OGMCOAL - Gordon Creek 2, 7, 8 Water Quality Memo - 1st Qtr 2010

# WATER QUALITY MEMORANDUM

SUBJECT: 2010 1st Quarter Water Monitoring, Mountain Coal Company, Gordon Creek 2, 7, & 8 Mine, C/007/0016, WQ10-1, Task ID 3477

Plots showing water monitoring results for stream location 2-2-W  
(Red triangles denote samples collected during first quarter)

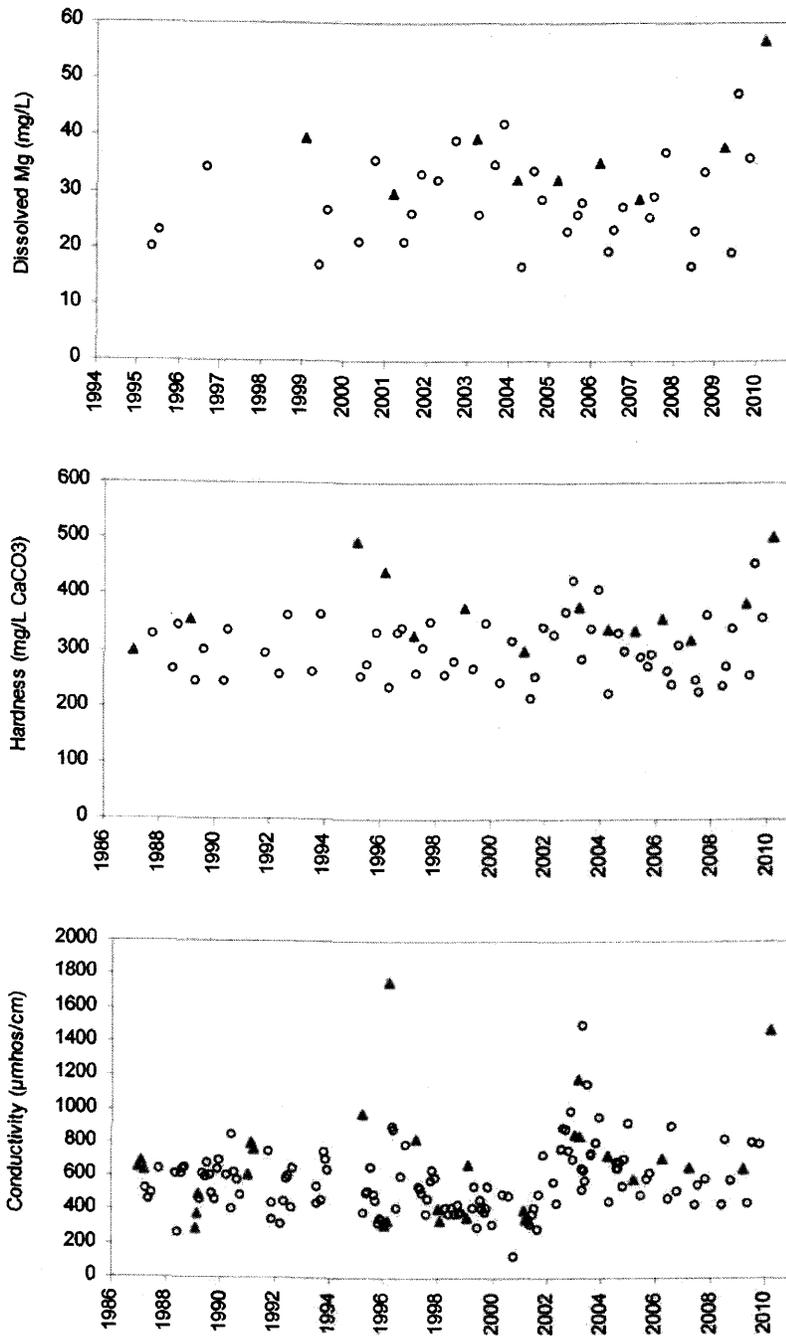
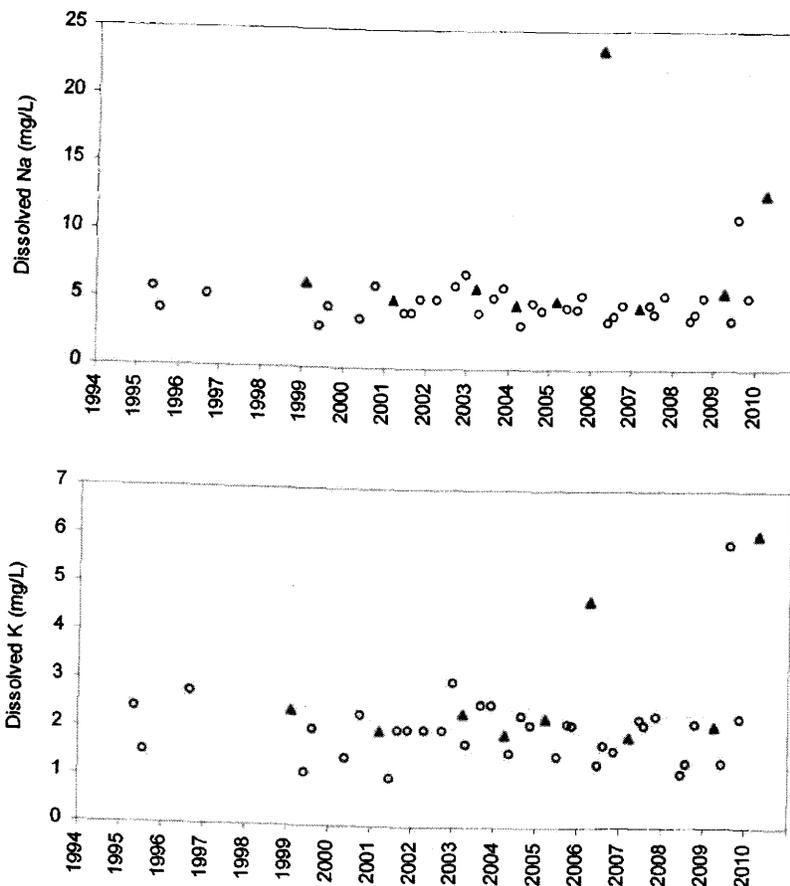
Results for the following eight constituents were greater than the average values (to date) by greater than two standard deviations in the March 29, 2010 sample at location 2-2-W: total cations, total anions, dissolved calcium, dissolved magnesium, hardness, conductivity, dissolved sodium and dissolved potassium. The cation – anion balance for the sample (3.95 %) was acceptable. The table below summarizes results for first quarter 2010, selected statistics from the data set, and the previous maximum values.

The plots on the following pages show available data for location 2-2-W for the eight monitoring constituents that were elevated above the average value by greater than two standard deviations in the first quarter 2010 sample. The red triangles denote samples collected during the first quarter; hollow circles denote samples collected during second, third and fourth quarters.

According to the MRP, monitoring is performed to provide information on the seasonal flow and water quality on streams that have a potential to be affected by mine discharge and surface disturbance. The Permittee expressed that the heavy runoff occurring at the time of sampling appears to have influenced the total dissolved solids (TDS) and metals concentrations in the first quarter 2010 sample. The TDS concentrations in the sample was 596 mg/L, which is well below the applicable UT water quality standard of 1,200 mg/L. The total suspended solids (TSS) concentration in the sample, 10 mg/L, is not elevated relative to measured TSS concentrations in the creek.

The elevated concentrations of dissolved constituents in the first quarter 2010 sample at location 2-2-W appear to be related to the spring flush during snowmelt. The sample results do not indicate impacts from mining or reclamation activities at the Gordon Creek 2, 7 & 8 mines.
